## MEMORANDUM - WESTERN DAVENPORT WATER ALLOCATION PLAN (2023-2033) AND SUPPORTING DOCUMENTS REVIEW

PREPARED FOR | Central Land Council - Northern Territory

PREPARED BY | Hydro Geo Enviro Pty Ltd, Dr Ryan Vogwill, Director

DATE | 2/05/2023

**Figure - (Upper) Thring Swamp bore RN018338 (Lower) model calibration hydrograph from Knapton, (2017). Note the difference with the model prediction showing the bore fluctuating from ~2-6m below the surface instead of ~0-2m.**

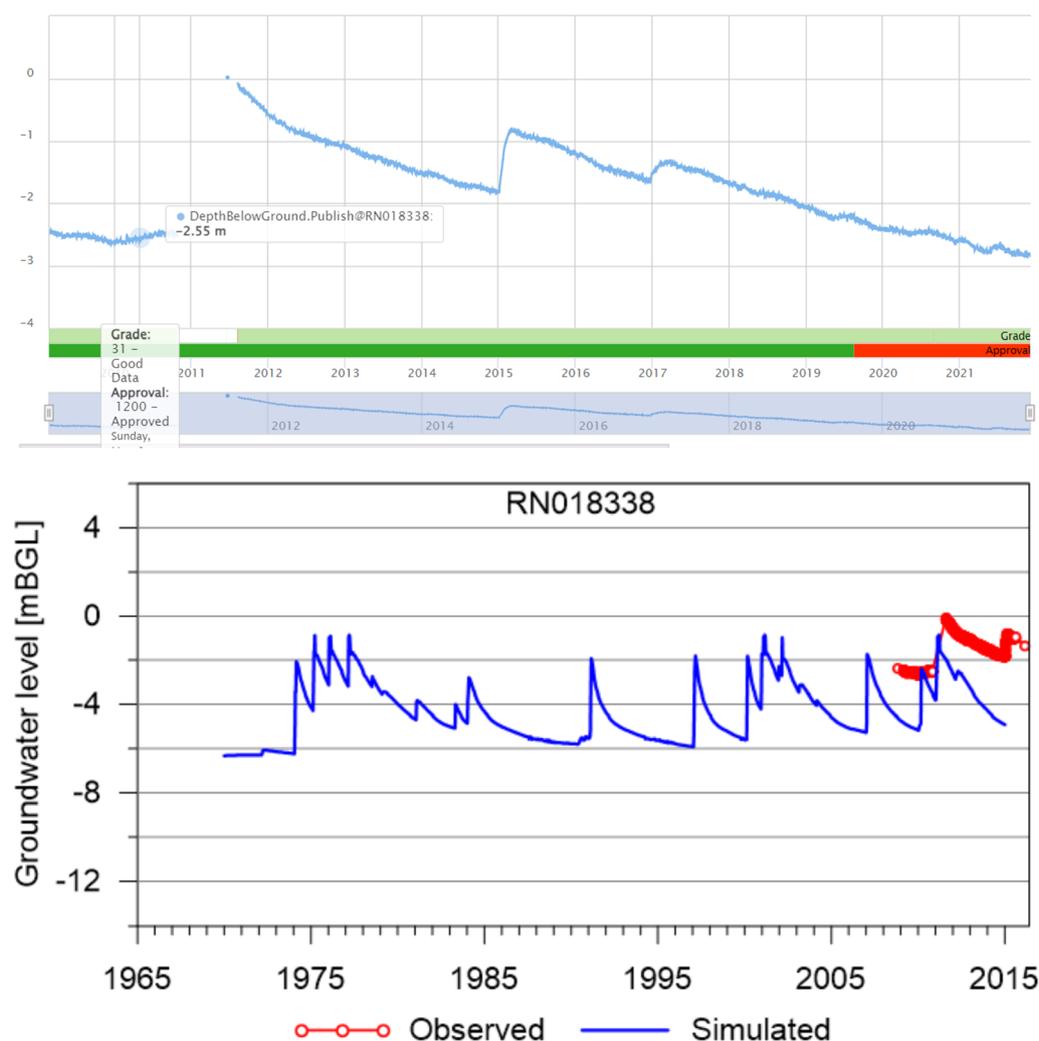
There is also an ongoing issue (in all of WAP versions) with the use of model derived highly uncertain groundwater levels to estimate the area of GDE impact risk. For example, the WAP background document correctly identifies that Thring Swamp is a high value biodiversity and cultural asset that

has a depth to groundwater of 5m or less. Available groundwater data from one of the bores near Thring Swamp (see figure below) show that the depth to groundwater at that location is consistently below 5m, has been 0m in 2011 (i.e. at the surface) and is generally about 1.5m. This area is predicted to impacted by drawdown but the lack of predictive uncertainty analysis of the groundwater modelling makes it difficult to assess the timing and magnitude of drawdown. The groundwater model does not accurately (see figure below) represent this important biodiversity asset/high cultural value site, which urgently needs a detailed assessment of aquifer connectivity and groundwater dependence. Showing all depth to groundwater contours <15m at 1m interval would be preferable to facilitate comparison with measured groundwater data.

Figure 6. Cumulative residual rainfall (mm) measured at Ali Curung (BoM Station ID 015502)

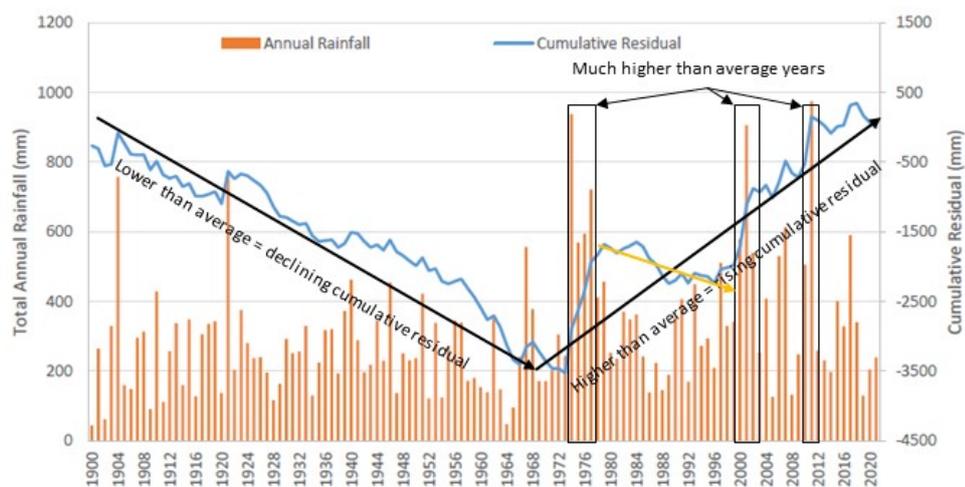
Page 13 - “Both charts provide evidence of an increasing trend in rainfall across the district since approximately 1972.”

Comment - The data isn’t that simple. An annotated version of the climate graph from the WAP background document is shown below. There is a period of average to less than average rainfall that spans 1980 to 2000 (see yellow arrows). The series of 4 significant rainfall years in the late 70’s accounts for about half of the “increasing rainfall trend” at Ali Curung. This effect is even more pronounced in the Barrow Creek dataset with rising trend in the 4 late 1970’s years, 2001, 2002, 2009 and 2010 accounting for this increasing trend.
